re: ALDAN LODGE, WELLINGTON STREET, PICTON (BC: 011291)

ALDAN LODGE
 STORMWATER INVESTIGATION
 PICTON.

Building Consent No. 011291

SITE PLAN
 1:250

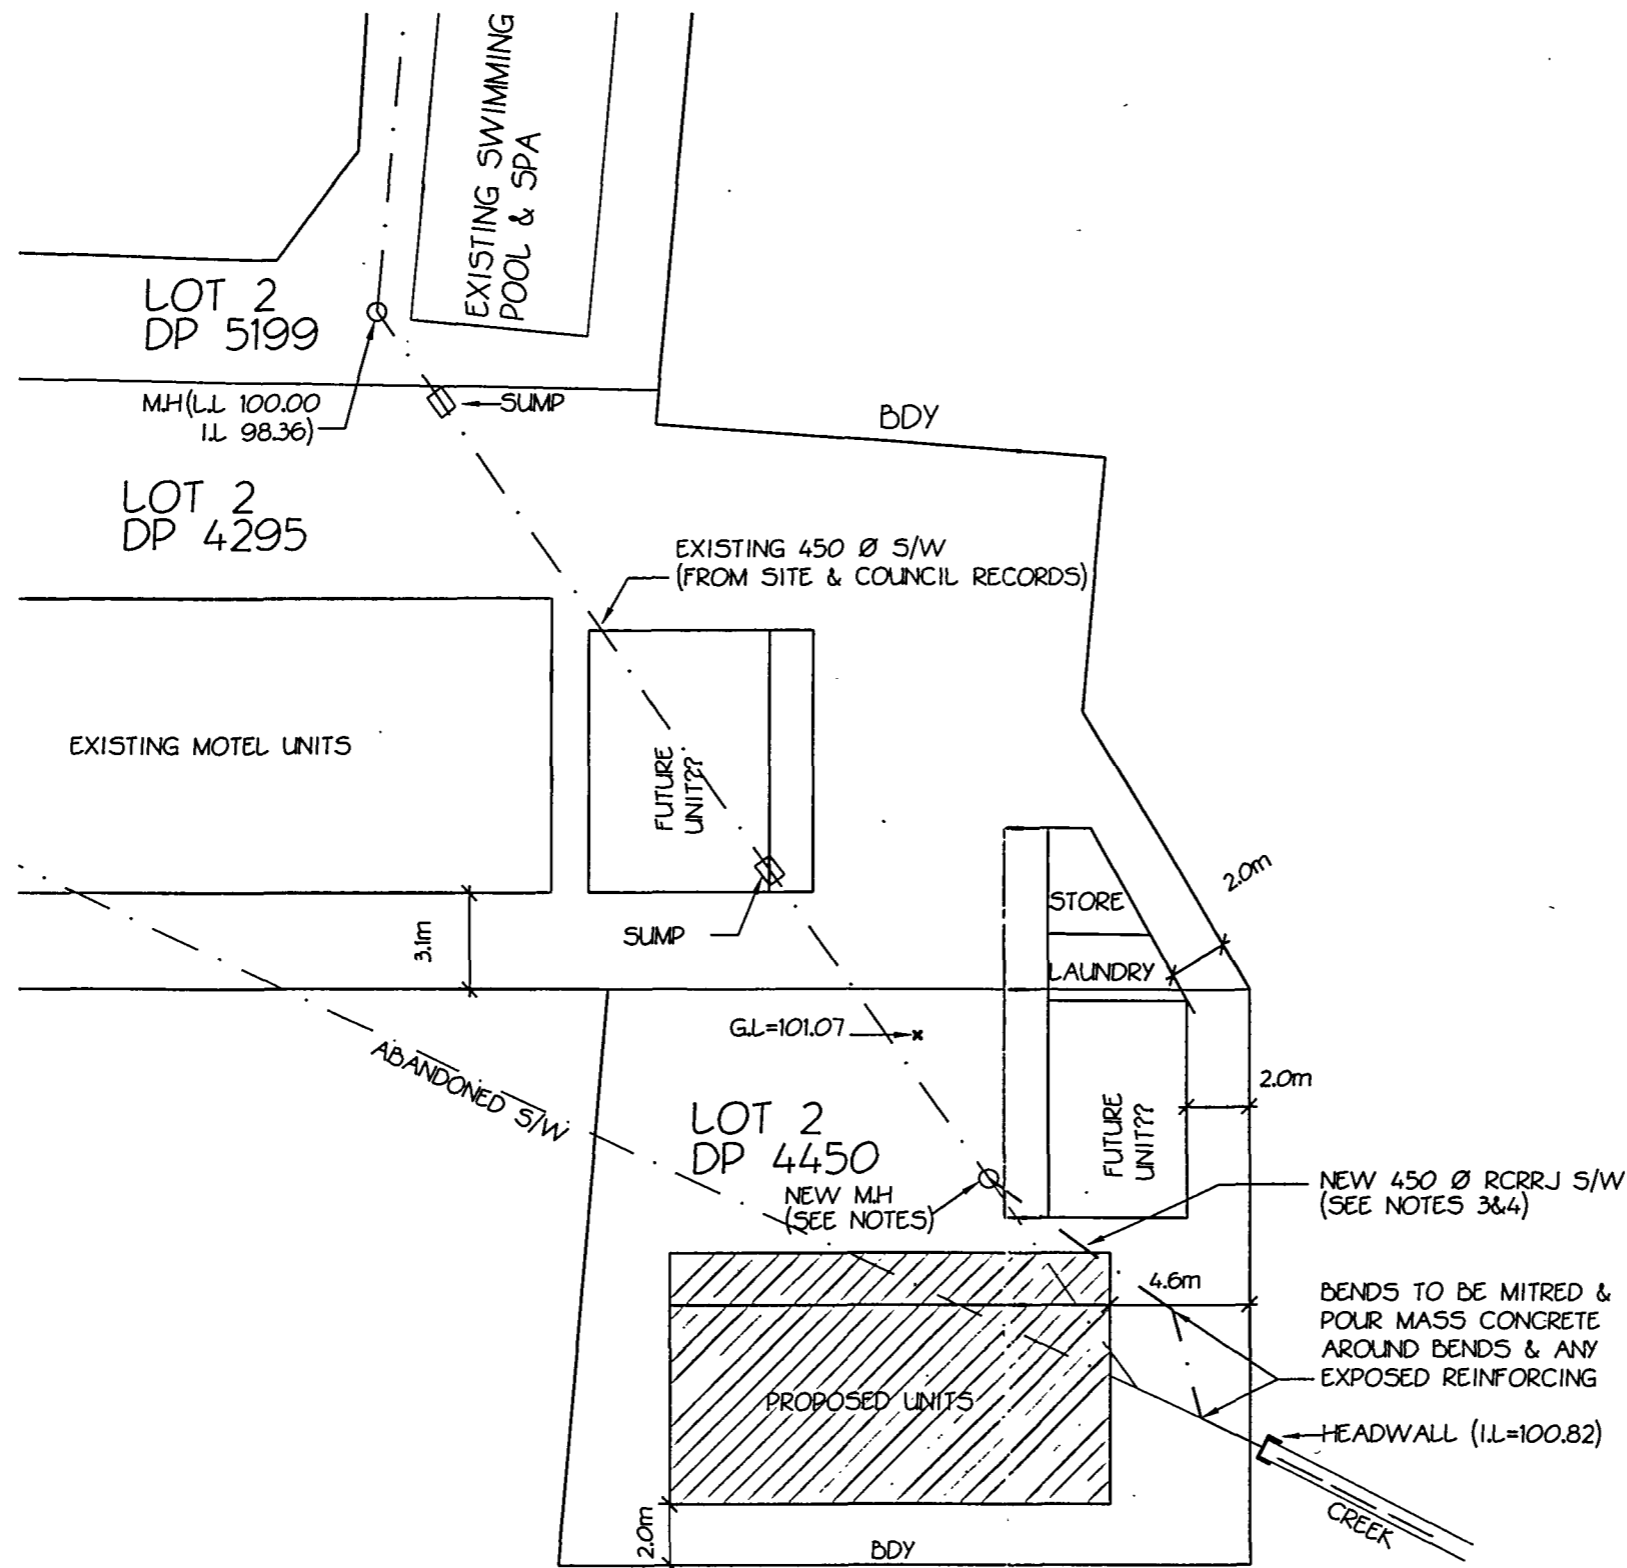
Please find attached three copies of plan number 22040/S1 showing the proposed work to the existing 450 mm diameter stormwater culvert to avoid passing under the building.

ALDAN LODGE
SHEET TITLE
SITE PLAN

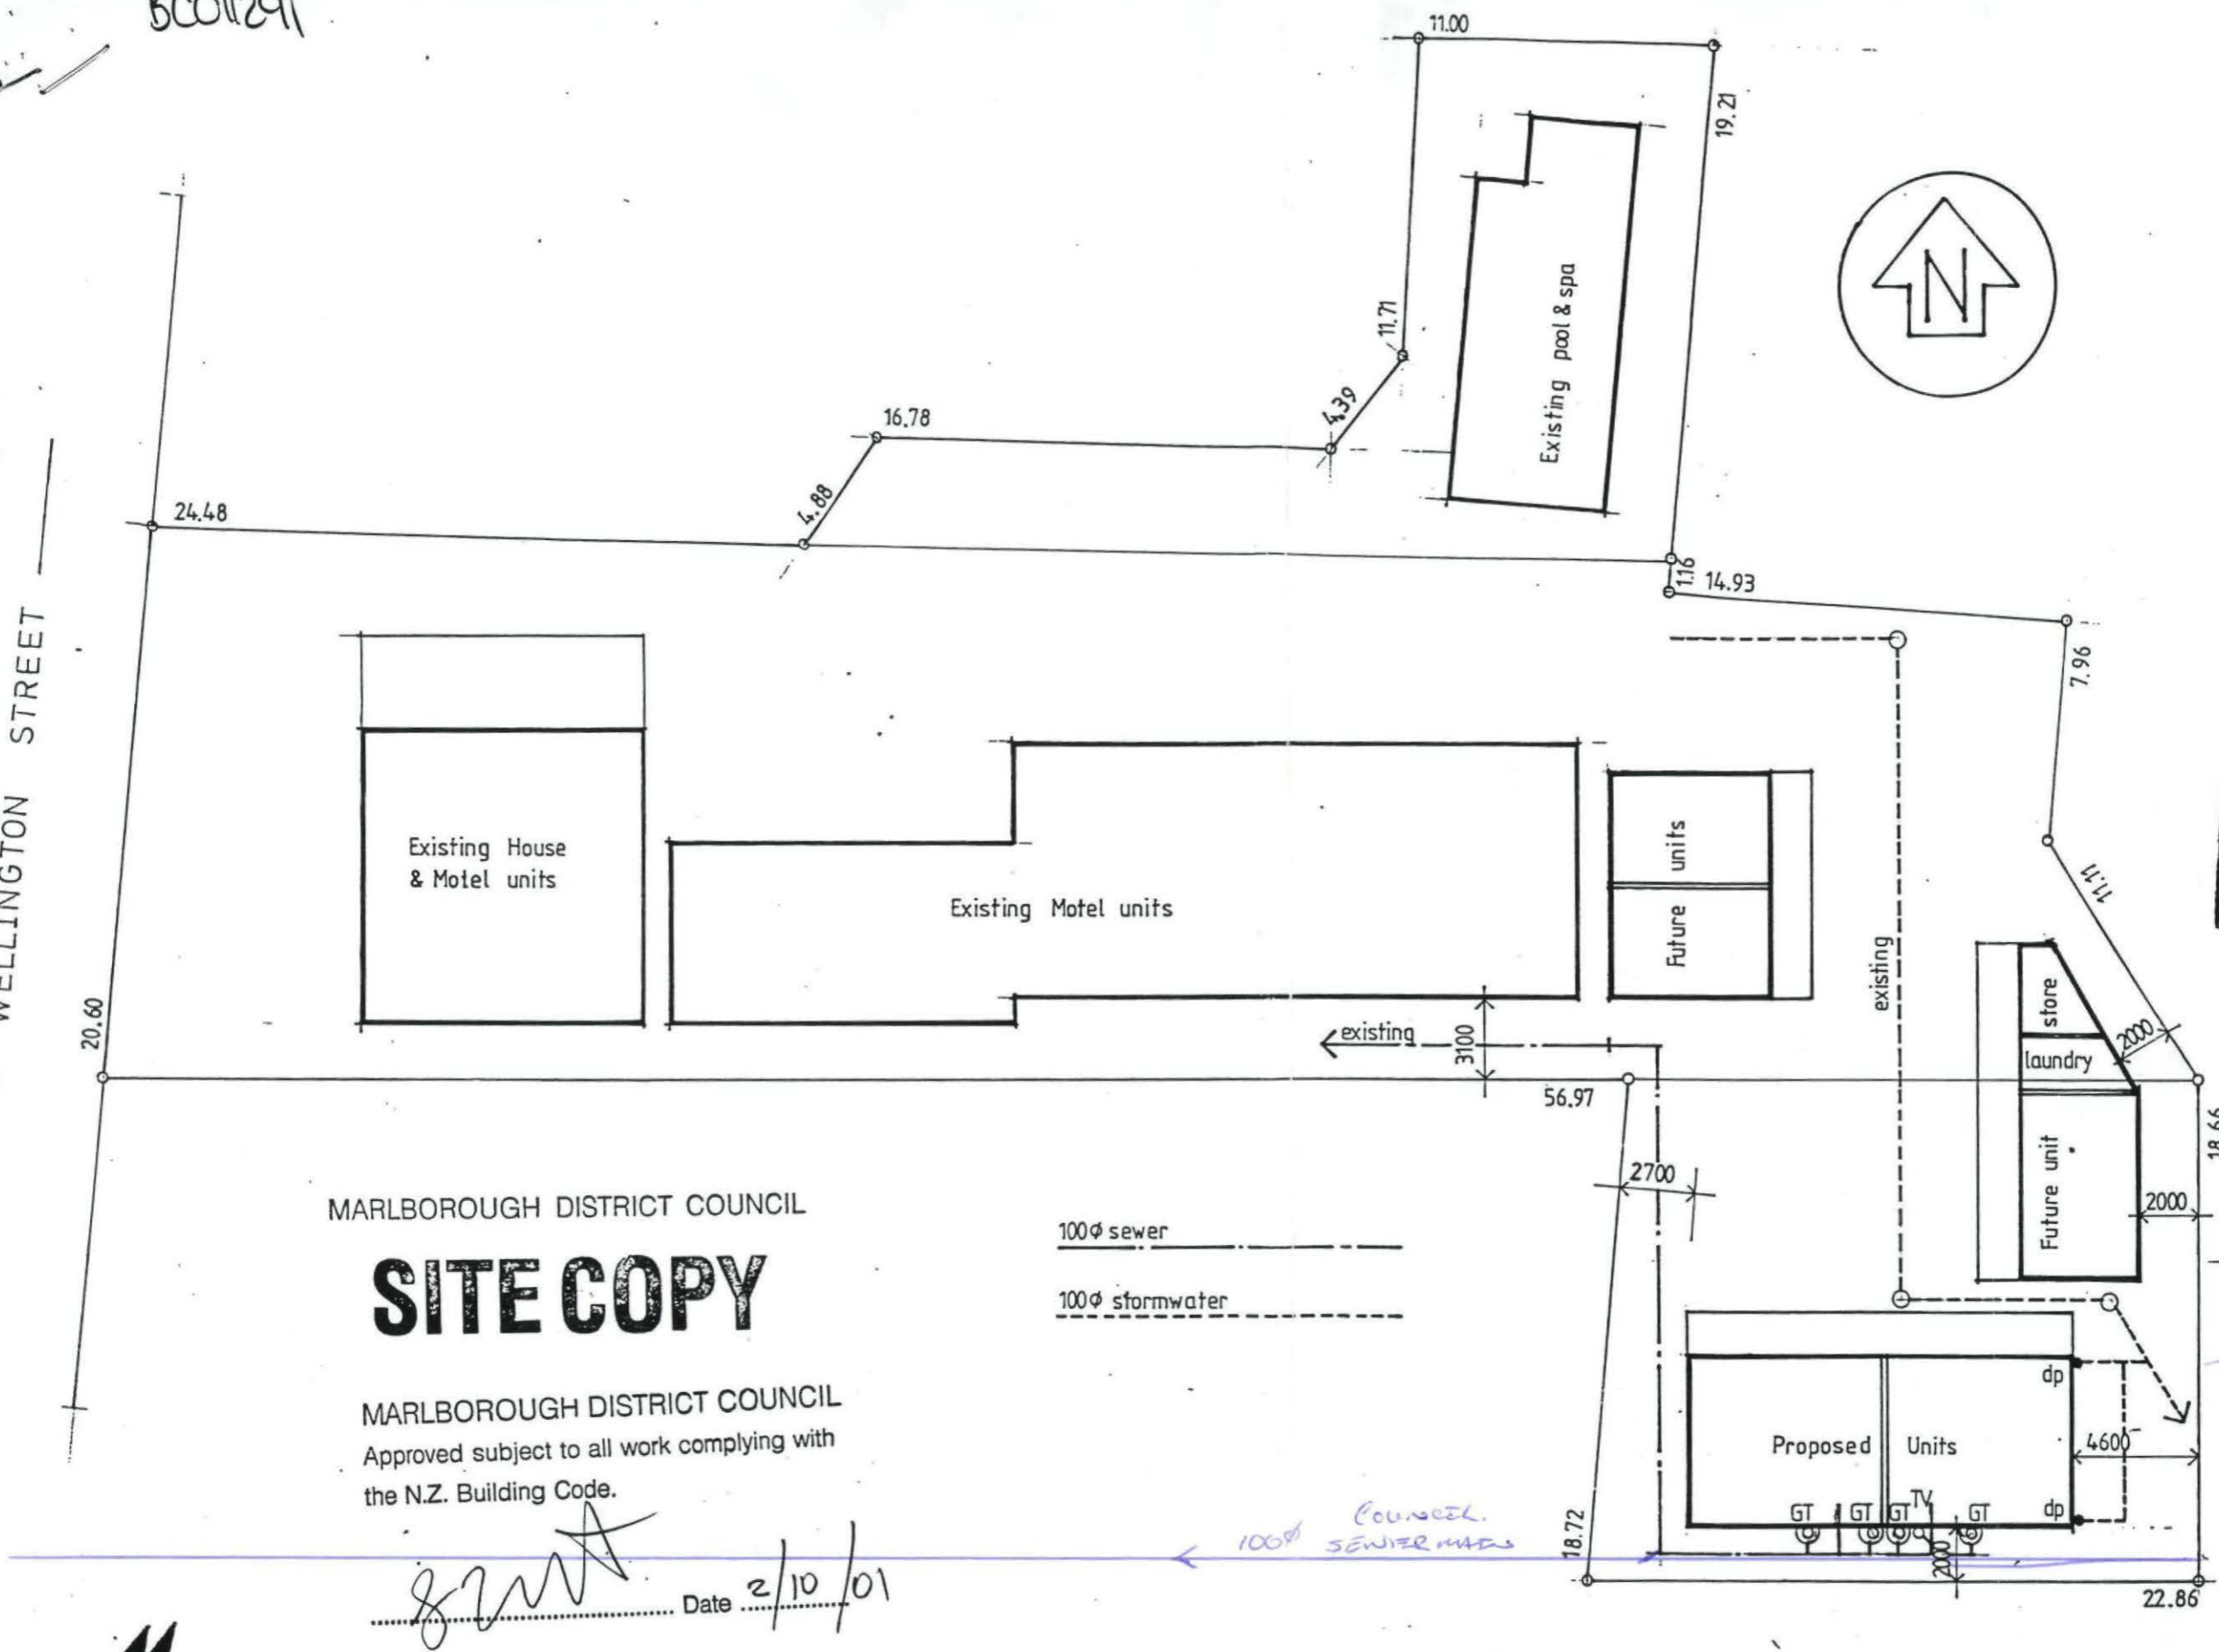
10/10/01
Kerry Walsh has approved this drainage amendment.

SITE PLAN
 1:250

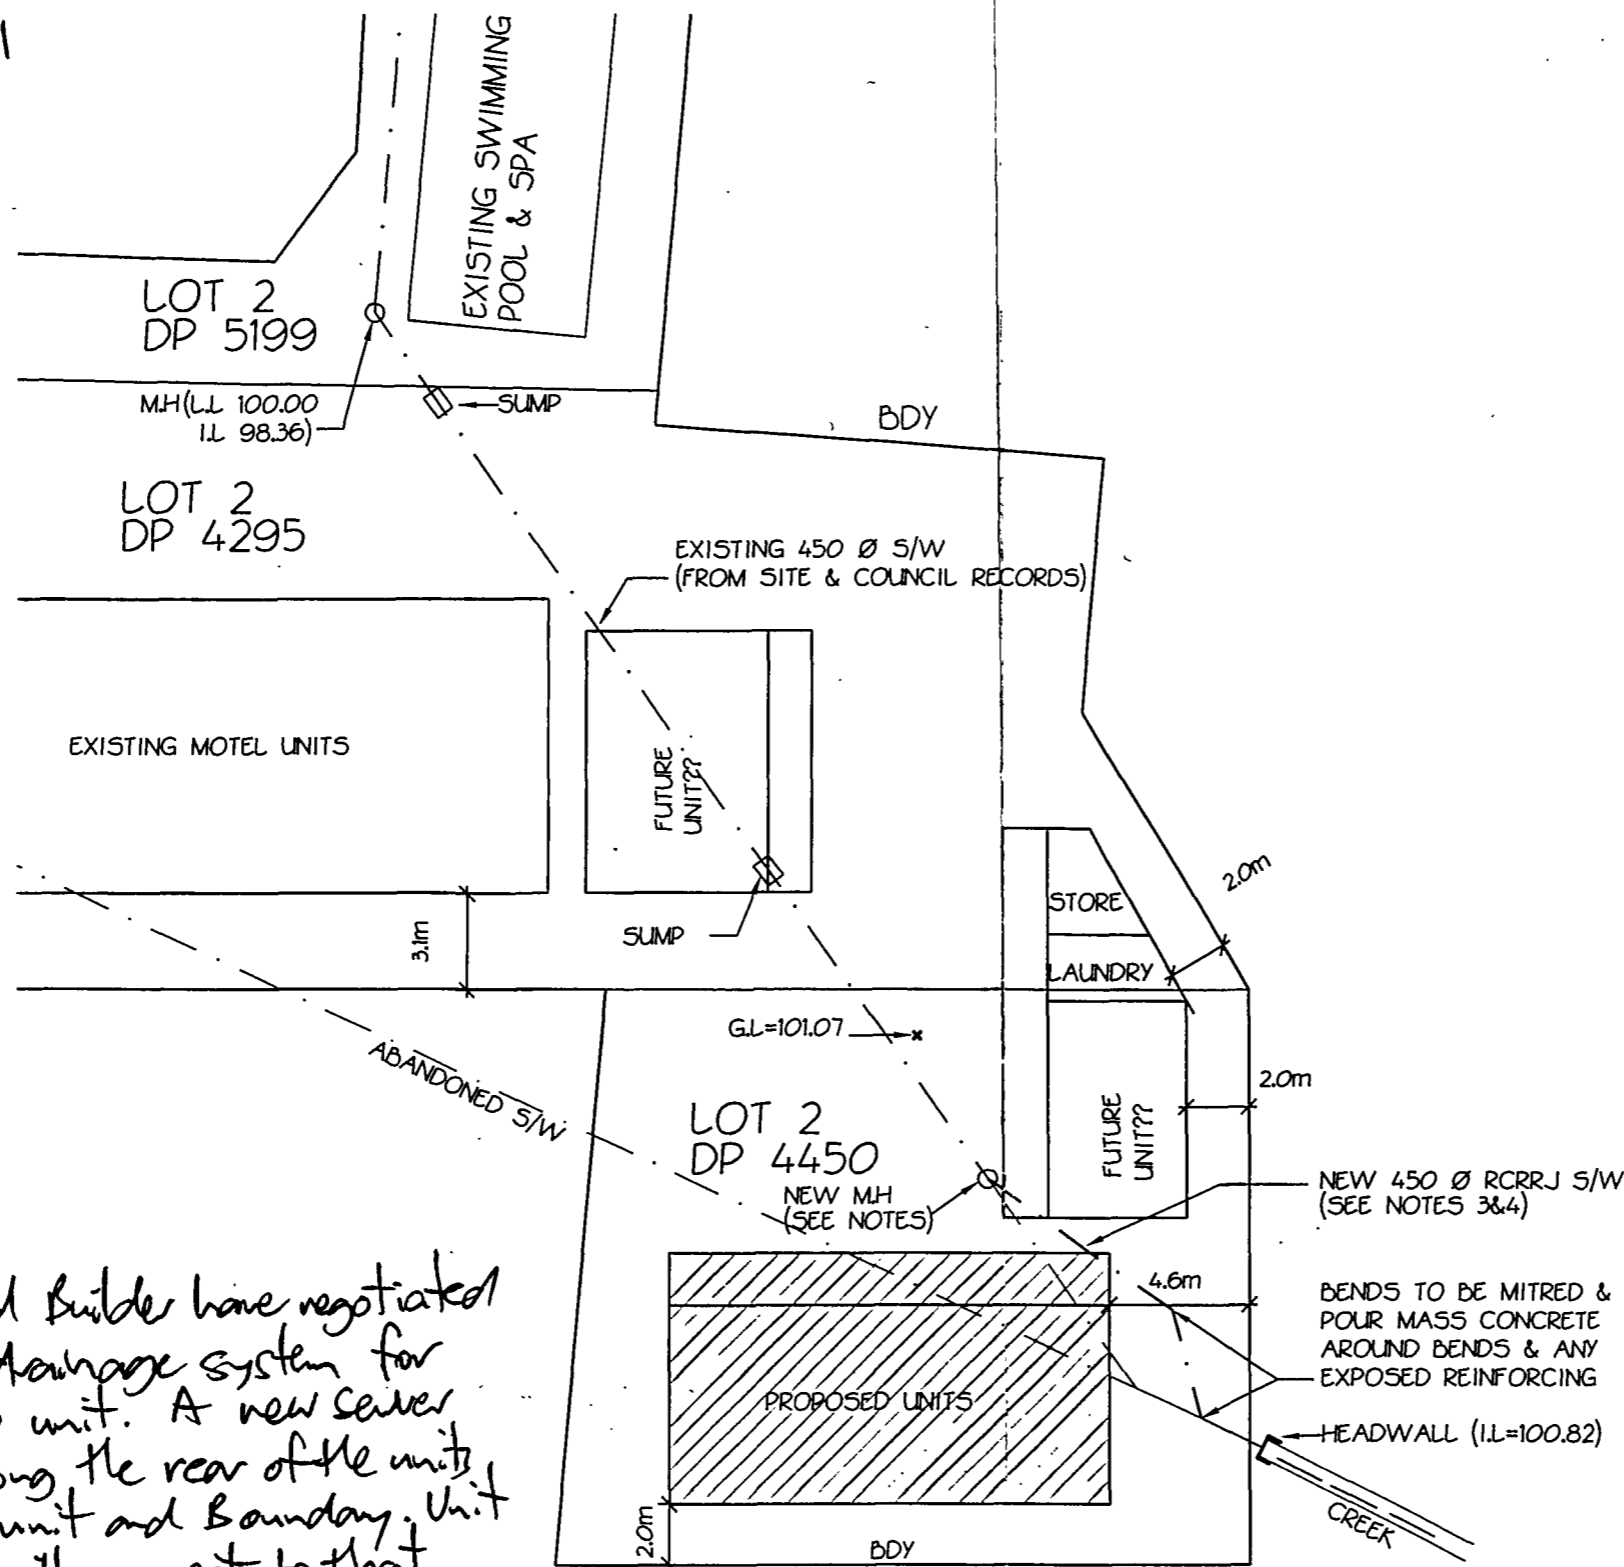
Note
 Owner and Builder have negotiated revised drainage system for the new unit. A new sewer runs along the rear of the unit between unit and Boundary. Unit sewage will connect to that. S.W. is slightly different to this plan but is similar. Kerry Walsh has negotiated the change & WWA 1/11/01.
